# Googong township water cycle project

Environmental assessment  
Submissions report

May 2011

**Figure 3** Water quality monitoring sites on the Queanbeyan River

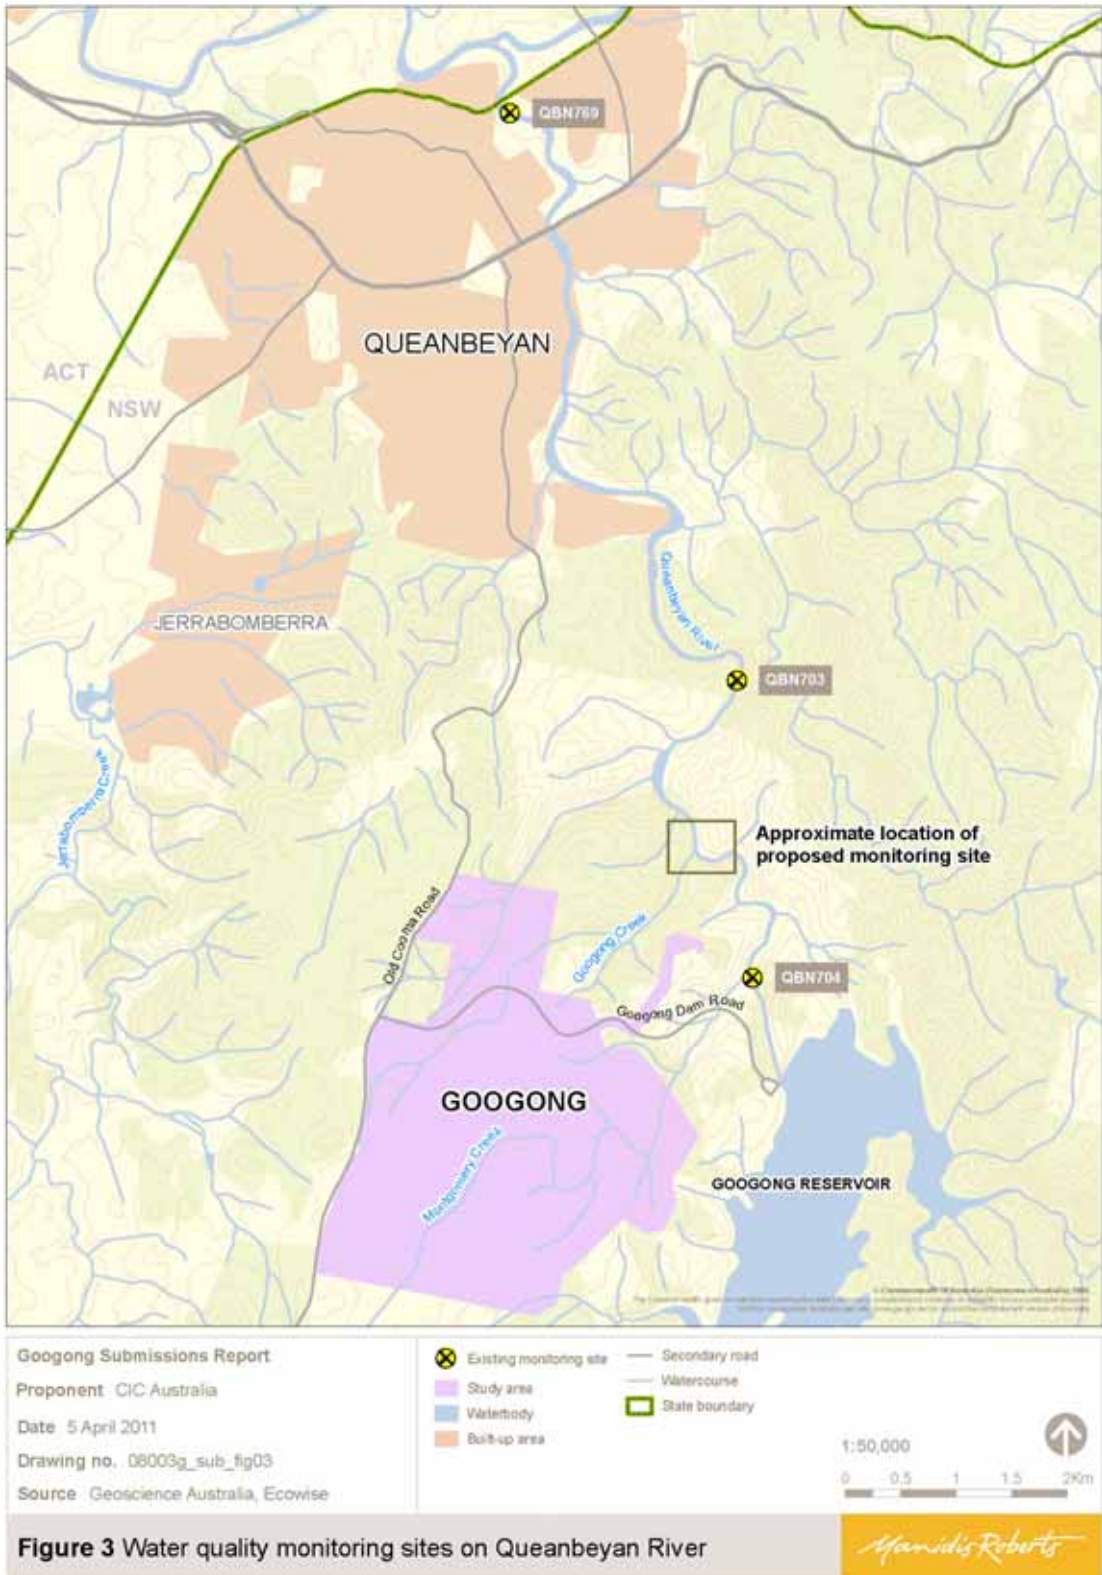
ID	Comment	Response	Reference
<b>Wickerslack Lane resident(s) #2</b>			
6A	Seeks clarification as to why the 75 <sup>th</sup> percentile and maximum faecal coliform concentrations presented in Table 7.2 of the EA for the Wickerslack Lane monitoring site are the same.	<ul style="list-style-type: none"> <li>Table 7.2 of the EA provides water quality information for the three (3) monitoring sites (QBN 704, QBN 703 and QBN 769) on the Queanbeyan River. These sites are shown in Figure 3 of this report. This water quality information was obtained from extracted data prepared by Ecowise Environmental (as part of the preliminary assessment report undertaken in 2008) for the period 1994 – 2008 for ACTEW Corporation. Only one (1) faecal coliform sample was taken at that site during the sampling period. Therefore, the 75<sup>th</sup> percentile and maximum values are the same.</li> </ul>	<ul style="list-style-type: none"> <li>Table 7.2 of the EA.</li> <li>Figure 3 of this report.</li> </ul>

This is consistent with results from the existing monitoring locations (as shown in Figure 3), namely, 1km downstream of Googong Dam (QBN 704) and the downstream stretch of the river (ie Wickerslack Lane, QBN 703). QBN 703 is located on the Queanbeyan River below its confluence with Googong Creek, which will receive discharges from the Project via the stormwater management system.

**Figure 4** Basin locations

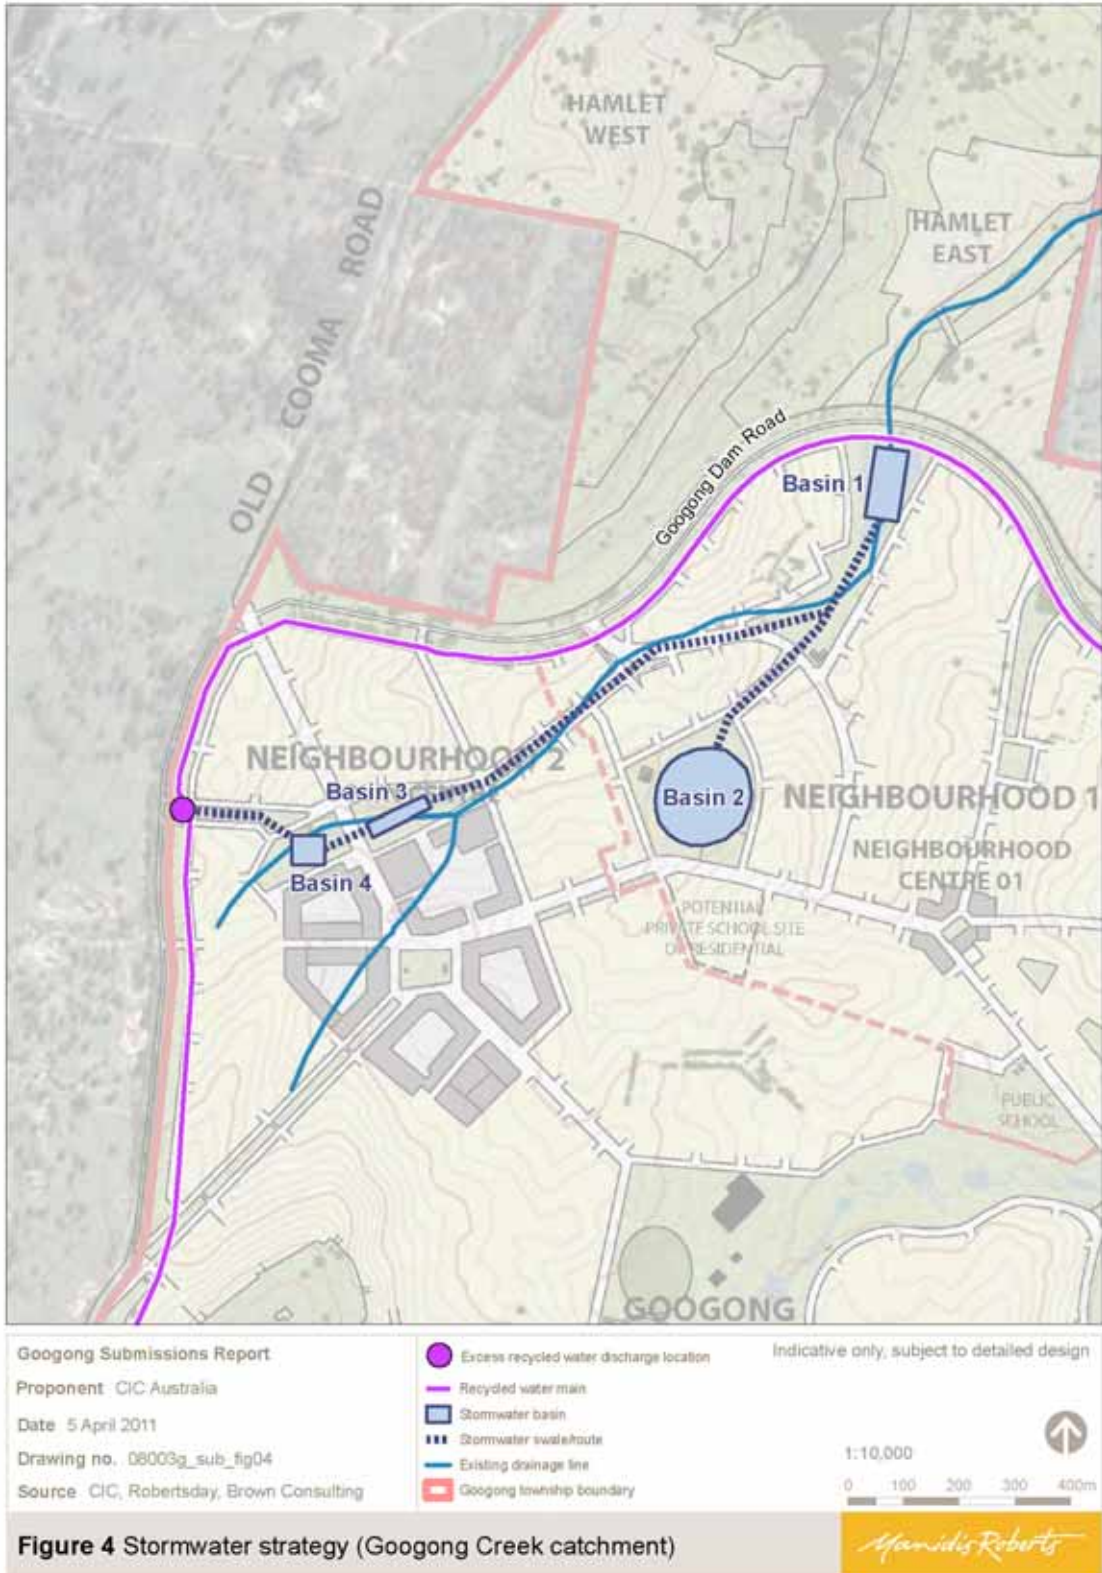
10E	Consider the impacts to the flow regime and ecology of Montgomery Creek. Confirmation is requested as to why this has not been addressed within the EA in consideration of the concept plan status and overall proposed assessment of the Googong Township development.	<ul style="list-style-type: none"> <li>Impacts of the discharge of excess recycled water on the flow regime and ecology of Montgomery Creek due to the Project being assessed under Part 3A of the EP&amp;A Act are not possible. All these discharges from the WRP will be to the Googong Creek catchment (as shown in Figure 4 of this report), which flows directly to the Queanbeyan River. No flows will be discharged to the catchment of Montgomery Creek.</li> <li>Impacts on Montgomery Creek have been considered and assessed separately under Part 4 of the EP&amp;A Act, as part of the assessment of the stormwater management strategy.</li> <li>The masterplan for the Googong township has considered the Montgomery Creek corridor in detail and includes the restoration of the original 'chain of ponds' creek form, which has been altered by the installation of farm dams during the past agricultural uses of the site.</li> </ul>	<ul style="list-style-type: none"> <li>Figure 4 of this report.</li> </ul>

The locations of these basins are shown in Figure 4 of this report, which also shows the approximate location of discharge of excess recycled water into the stormwater management system.

High quality excess recycled water would be released into the stormwater management system upstream of Basin 4 (refer to Figure 4 of this report). The Stormwater Management Strategy has considered the release of excess recycled water into the system in a similar way as it considers the flow and water quality of other input into the catchment from upstream and offsite on the western side of Old Cooma Road (ie as part of the overall management of the system). This has been determined as the most efficient and effective method to achieve high environmental outcomes of water quality and stream health. It should be noted that the recycled water that will be discharged is treated to be suitable for non-potable uses and human contact. However, as requested by the OEH, it would not be chlorinated (refer to Section 4.2 of this report).
